Access Compliance Report Public Rights-of-Way (Curb Ramps)

Main Street: PALM_DR Cross Street: ROXBOROUGH_DR Location: N

ADA ID: RPRK220201130315 Ramp Type: Type 4 - Parallel Initial Pass/Fail: Fail Overall Compliance: No Severity Score: 15

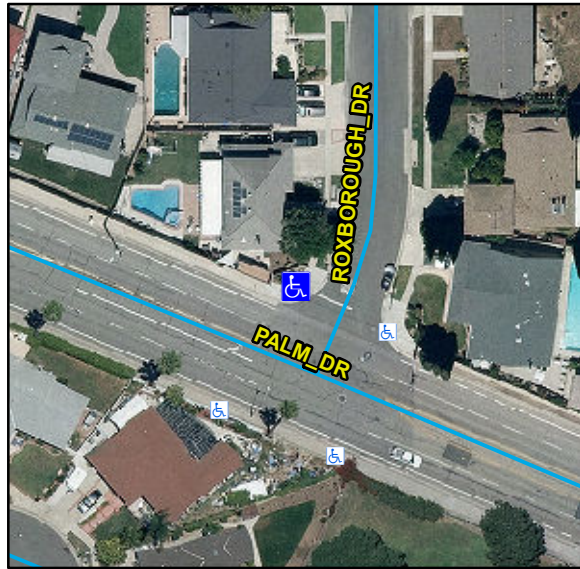
Compliance	Description	Data	Compliance	Description	Data
N/A	Ramp Length LT (in)	88	N/A	Ramp Length RT (in)	100
Yes	Ramp Width LT (in)	109	Yes	Ramp Width RT (in)	109
Yes	Ramp Run Slope LT (%)	4.8	Yes	Ramp Run Slope RT (%)	3.2
No	Ramp Cross Slope LT (%)	5.4	No	Ramp Cross Slope RT (%)	3.2
N/A	Landing Present	N/A	N/A	DWS Provided	N/A
N/A	Landing Length (in)	N/A	N/A	DWS Contrast	N/A
N/A	Landing Width (in)	N/A	N/A	DWS Length (in)	N/A
N/A	Landing Run Slope (%)	N/A	N/A	DWS Full Width	N/A
N/A	Landing Cross Slope (%)	N/A		DWS Offset Type	N/A
N/A	Landing Movement Obstructed?	N/A	N/A	DWS Offset Left (in)	N/A
	Landing Movement Type	N/A	N/A	DWS Offset Right (in)	N/A
N/A	Landing Shared	N/A			
N/A	Clear Space	Yes			
N/A	Clear Space To Crosswalk (in)	N/A			
N/A	Marked Crosswalk 1	No	N/A	Marked Crosswalk 2	No
	Crossing 1 Direction	SW		Crossing 2 Direction	SE
	Marked Crosswalk 1 Width (in)	N/A		Marked Crosswalk 2 Width (in)	N/A

Remove & Replace Curb Ramp With Two New Directional Ramps or Equivalent.

R304.5.3, STD 1115
